INDIANA UTILITY REGULATORY COMMISSION

<u>DIRECT TESTIMONY & ATTACHMENTS OF ELIZABETH A. STANTON, PHD, ON BEHALF OF CITIZENS ACTION COALITION OF INDIANA, INC.</u>

Direct Testimony of Elizabeth A. Stanton, PhD On Behalf of Citizens Action Coalition of Indiana, Inc. Cause No. 45195 March 15, 2019

Comments on NIPSCO's 2018 Integrated Resource Plan

Figure 3. NIPSCO 2018 IRP Figure 2-1: Overall Integrated Resource Planning Approach

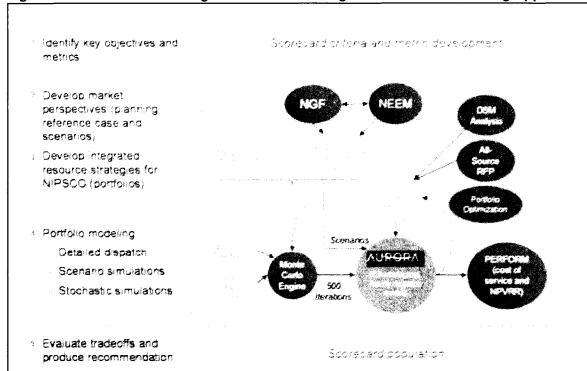
Section 2.3 in NIPSCO's IRP presents its resource planning approach (see Figure 3), including a description of the model structure and applicability. IRP Section 2.3 shows the steps NIPSCO undertook for their resource planning approach. The Company first conducted a retirement analysis and then developed its replacement portfolios. NIPSCO used Aurora's portfolio optimization tool to develop least-cost portfolios to replace retiring units in its modeling of retirement portfolios. After constructing portfolios, CRA would use Aurora to simulate hourly dispatch of the portfolios within the MISO market. The output from the Aurora dispatch is then used as an input to the PERFORM model in order to help construct the stream of annual revenue requirements of each portfolio.
